MILITARY SPECIFICATION SHEET

LOUDSPEAKER, PERMANENT MAGNET (ENCASED, 2-WATT, FUNGUS-, GUNBLAST-, AND IMERSSION-RESISTANT), TYPE LS-590( )/U

This amendment forms part of Military Specification Sheet MIL-L-12632/1A, dated 10 June 1974, and is approved by all Departments and Agencies of the Department of Defense.

FIGURE 3. Audio transformer

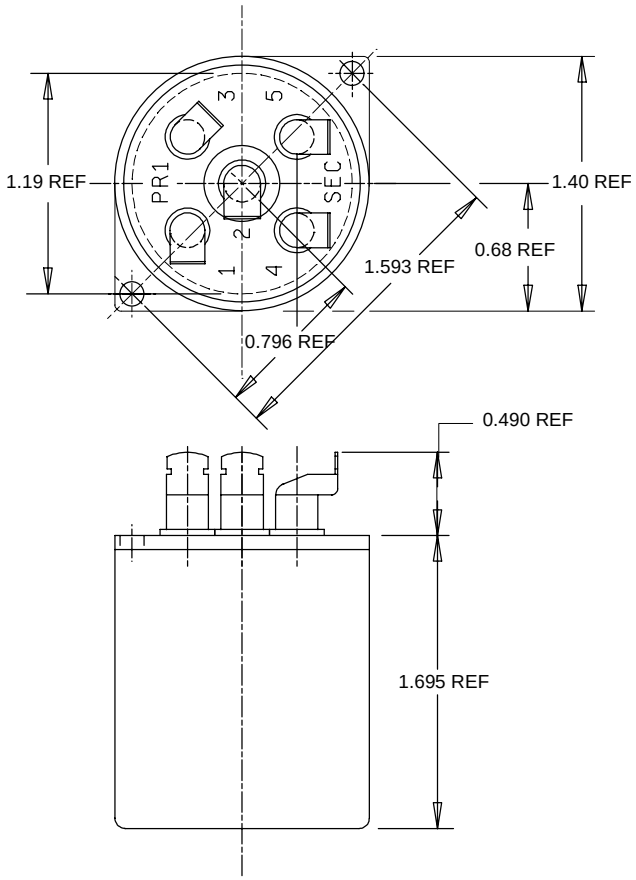
PAGE 3: FIGURE 3: Delete and substitute :

Audio transformer: Delete and substitute the following:

"Audio transformer - Type TF4R21YY of MIL-T-27/1 (P/N M27/1-01) in accordance with MIL-T-27 (see figure 3)."
